**TOWN OF BROOKLYN
PLANNING AND ZONING COMMISSION
Regular Meeting Agenda
Wednesday, October 6, 2021 6:30 p.m.**

- 2. **SPR 21-003:** Site Plan Review Application for ground-mounted solar panels at 80 South Street, 8.6 acres, RA Zone, Applicant: Consolidated Edison Solutions, Inc.

- 3. **SPR 21-004:** Site Plan Review Application for ground-mounted solar panels at 5 Front Street and 29 Tiffany Street, 1.8 acres, R-10 Zone, Applicant: CHIP Fund 6 LLC & CHIP Fund 8 LLC.

**RE: Proposed Solar Array – Front Street & Tiffany Street – Brooklyn, CT
P&R Job No. 213008**

1 SITE PLAN SETBACK
 SP-E2 SCALE: 1/64" = 1'-0"

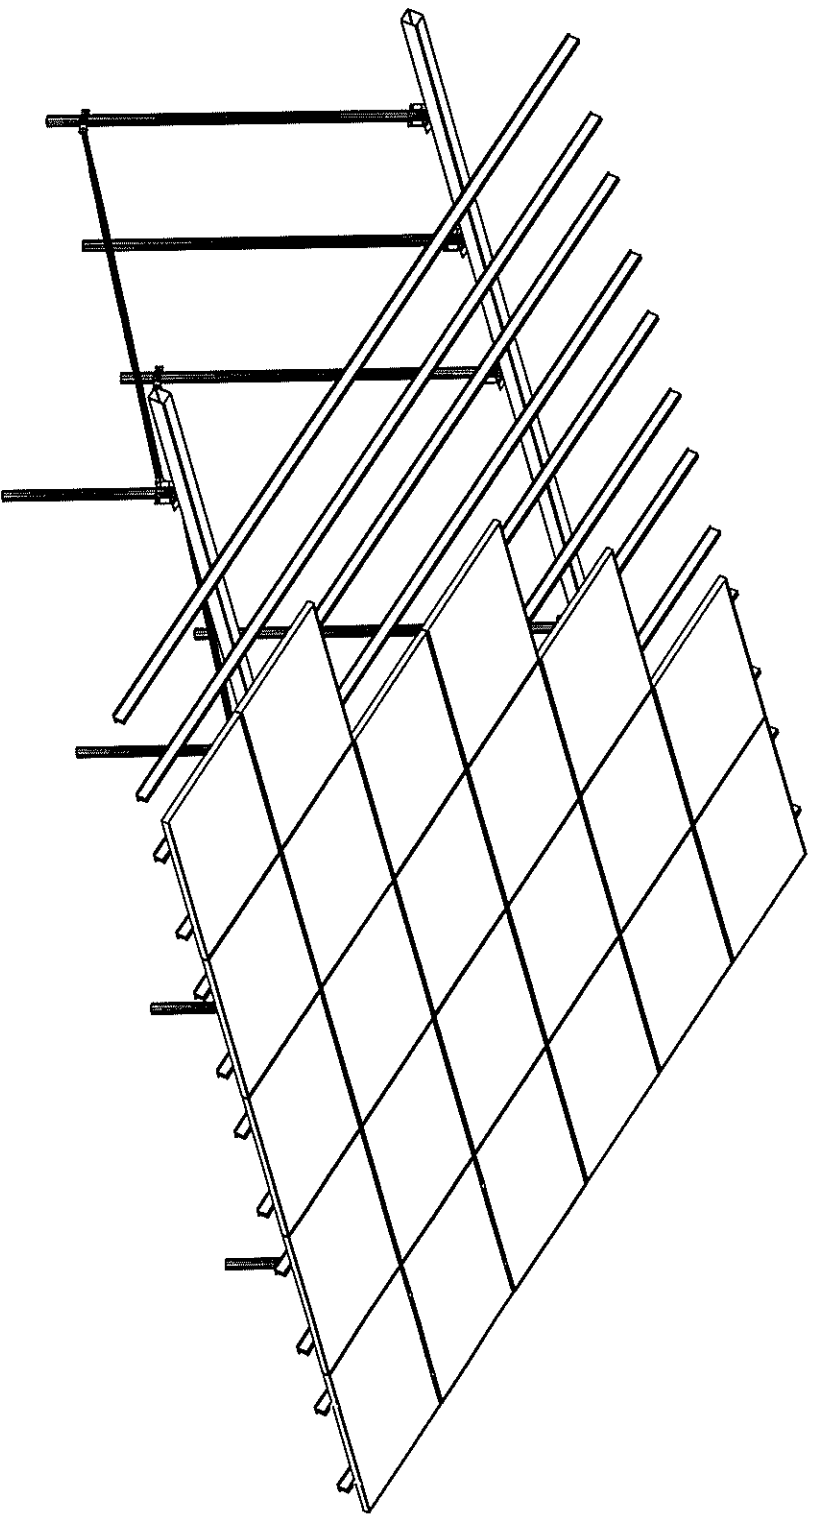
- 1) Is any kind of screening will be provided?
- 2) How has glare been addressed?
- 3) What is the max height of the structure?

- 1) We are not currently planning on any screening as the array is located so far from the road with no visibility from the road.
- 2) Please see attached report on Solar Panel Glare. Solar Panels are designed and coated to absorb the majority of the incident light such that there is minimum glare. Also keep in mind that the angle of reflection equals the angle of incidence such that any light hitting the panels which are a 26 degree tilt would be reflected off at 56 degrees.
- 3) The max height at the rear of the array is 10 feet 9 inches.

IMPROVEMENT LOCATION SURVEY
PROPOSED SOLAR ARRAY
PREPARED FOR
**CHIP FUND 6 LLC &
CHIP FUND 8 LLC**
FRONT STREET & TIFFANY STREET
BROOKLYN, CONNECTICUT

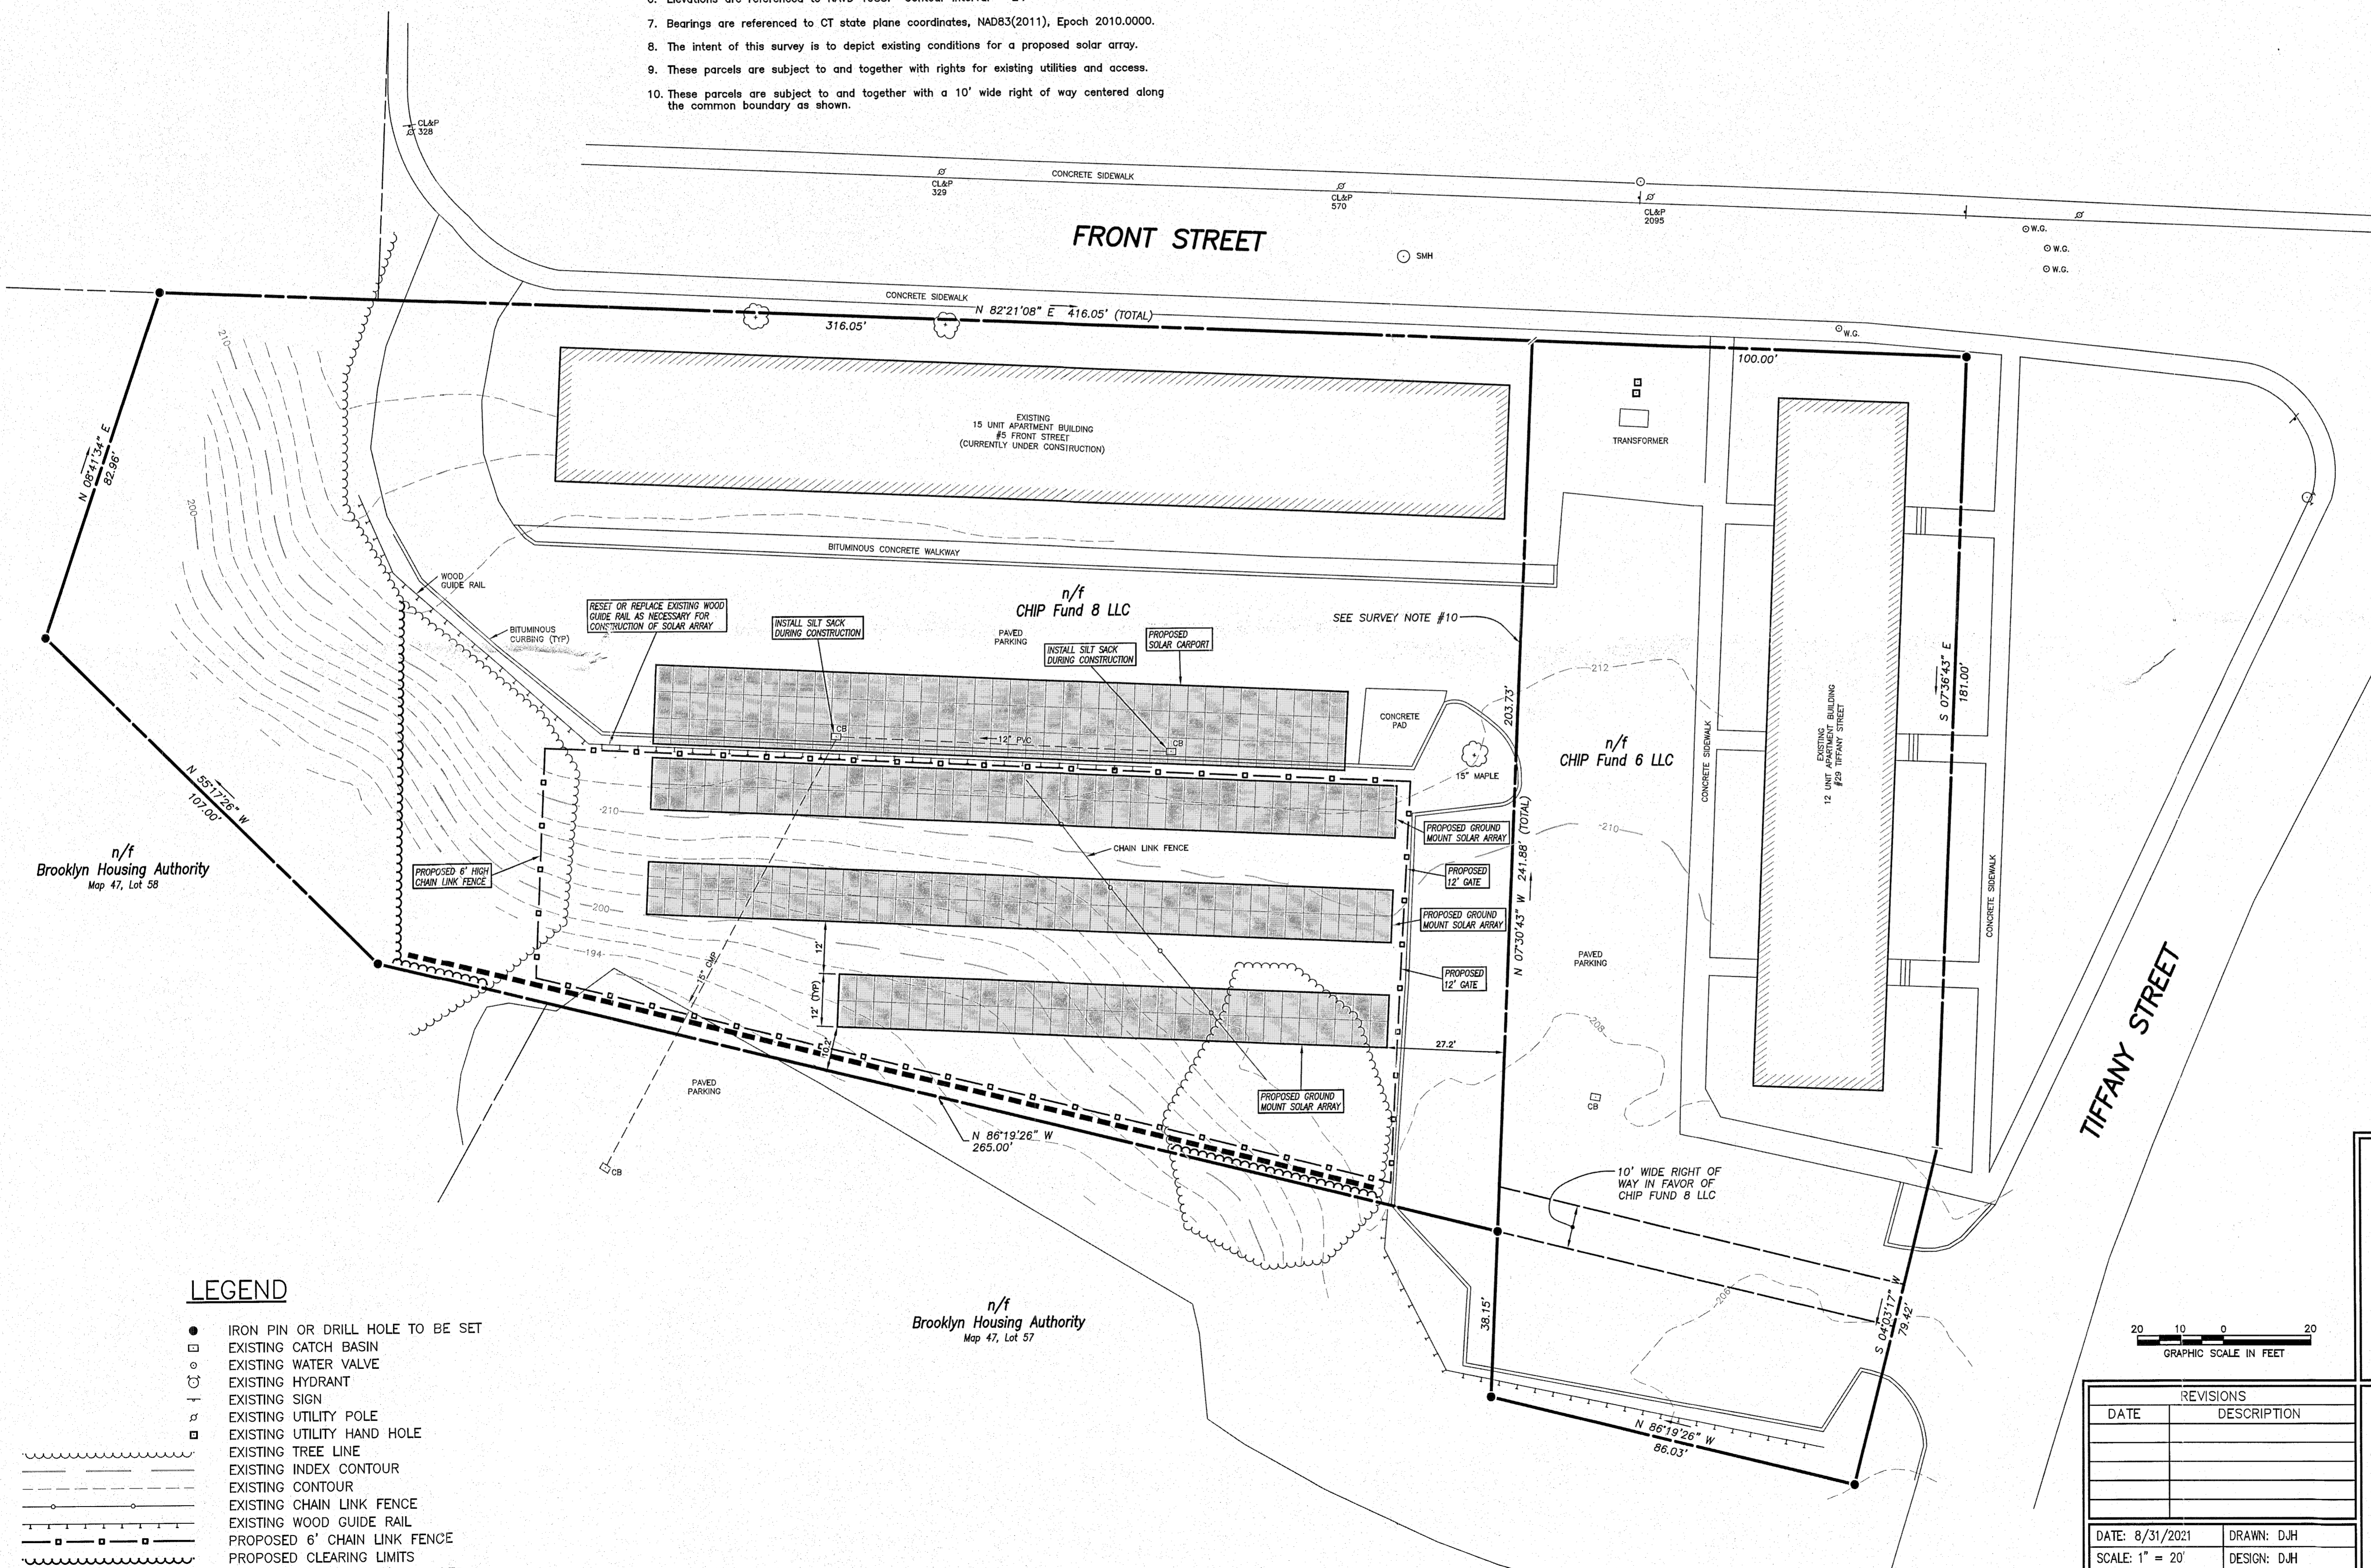
- 1) Are you aware you need to meet all setbacks? Or seek a waiver. R-10 zone setback for an accessory structure in the rear yard and/or side yard is 10'. The provided side and rear setbacks are 10.2' and 27.2' respectively. I assume these are the appropriate setbacks to use since it's an accessory use/structure but please correct me if I'm wrong about that.

- 2) Could you clarify what kind of screening will be provided? There is no particular screening proposed. Other than a small part of Tiffany Street, the ground mount array should be hidden from view in a public right of way by the buildings. If you feel additional screening is warranted, we could add wood slats or something similar on the easterly perimeter fence around the array.

- 3) How has glare been addressed? Glare would only be a potential concern for the ground mount portion of the project. Since it's not directly facing a public right of way and it's up higher than the adjacent parking lot to the south, I don't think there's much potential for glare to be an issue. Please let me know if there's a specific concern or location related to glare.

- 4) What is the max height of the structure? For the ground mount array, the maximum height above grade will be approximately 12'. Most locations will be lower than that because of the southerly slope of the land. The carport structure will be a maximum of 14' above grade.
